CITY PLAN COMMISSION**THURSDAY, MAY 2, 2024****FILE NUMBER:** S234-082**SENIOR PLANNER:** Sharmila Shrestha**LOCATION:** Roseland Avenue at Peak Street, south corner**DATE FILED:** April 3, 2024**ZONING:** PD 298 (Subarea 1)**PD LINK:** [Article 298.pdf \(dallascityhall.com\)](https://dallascityhall.com/Article%20298.pdf)**CITY COUNCIL DISTRICT:** 2**SIZE OF REQUEST:** 0.213-acre**APPLICANT/OWNER:** Geoffrey Wattiker

REQUEST: An application to replat a 0.213-acre tract of land containing part of Lot 10 and all of Lot 10A in City Block 3/649 to create one lot on property located on Roseland Avenue at Peak Street, south corner.

STAFF RECOMMENDATION: The request complies with the requirements of PD 298 (Subarea 1); therefore, staff recommends approval of the request subject to compliance with the following conditions:

PRELIMINARY PLAT

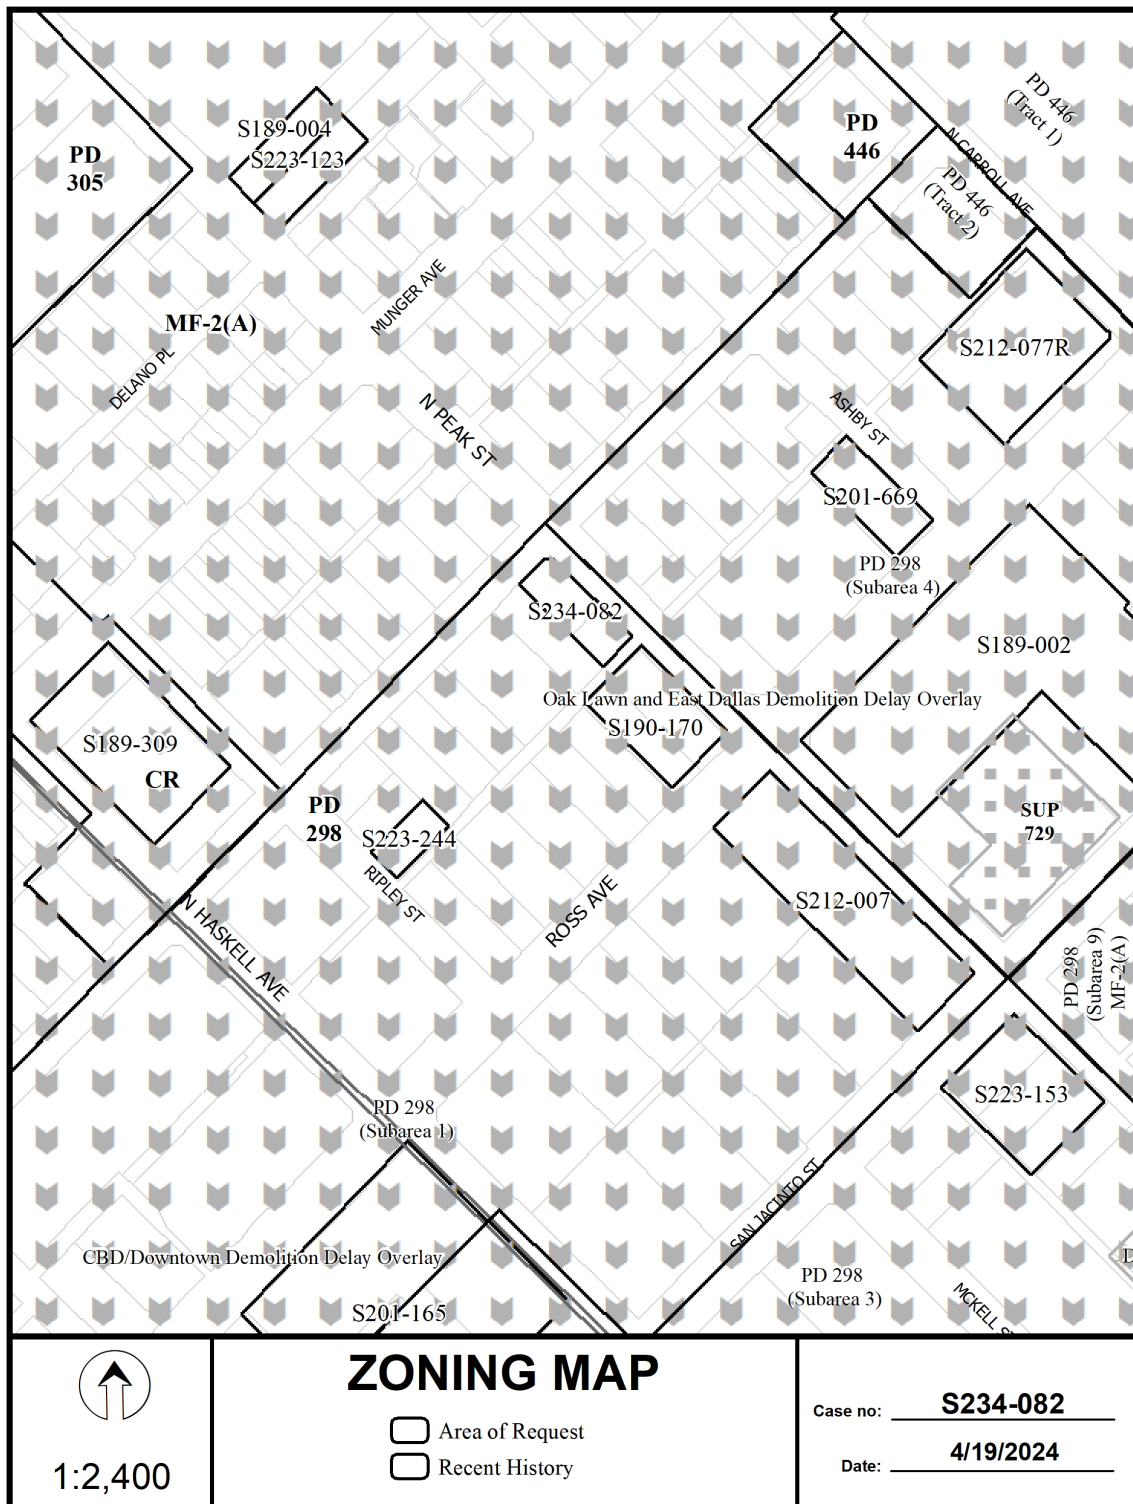
7. On the final plat, include two boundary corners tagged with these coordinates: "Texas State Plane Coordinate System, North Central Zone, North American Datum of 1983 on Grid Coordinate values, No Scale and no Projection."

15. On the final plat, dedicate 15-foot by 15-foot alley sight easement at Peak Street and Alley. Section 51A-8.602(e)
16. Comply with Mill Creek drainage requirements. Finish floor elevation must be 3' above nearest inlet, top of curb. 51A 8.611(d), C.9 of Mill Creek, Master Drainage Plan Study

17. Prior to final plat, submit a completed final plat checklist and all supporting documents.
18. On the final plat, show recording information on all existing easements within 150 feet of the property.
19. On the final plat, show all additions or tracts of land within 150 feet of the property with recording information.

23. On the final plat, change "Rosss Avenue" to "Ross Avenue".
24. On the final plat, change "FKA Flora Street Roseland Avenue" to "Roseland Avenue (FKA Flora Street)".
25. On the final plat, identify the property as Lot 10B in City Block 3/649.
